TECHNICAL BULLETIN

Bulletin Nº: 0017 CDS. ref: L8624bu

MODEL/DERIVATIVE: Discovery Series II

WATTS LINKAGE TORQUE SPECIFICATION

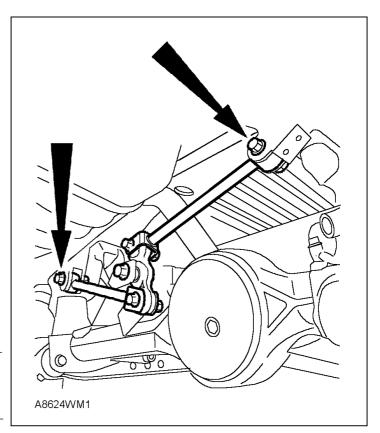
Amendments are required to the Workshop Manual Rear Suspension section and Torque Wrench Settings chart - Rear Suspension.

Published information incorrect.

Refer to Workshop Manual repair number 64.35.35 - Bushes - Watts linkage - Refit - Operation 6 and page 06-20 Torque Wrench Settings - Rear Suspension.

The correct torque setting for the 2 transverse link to chassis bolts (arrowed in illustration) is 140 Nm (103 lbf.ft). All other torque settings remain as stated.
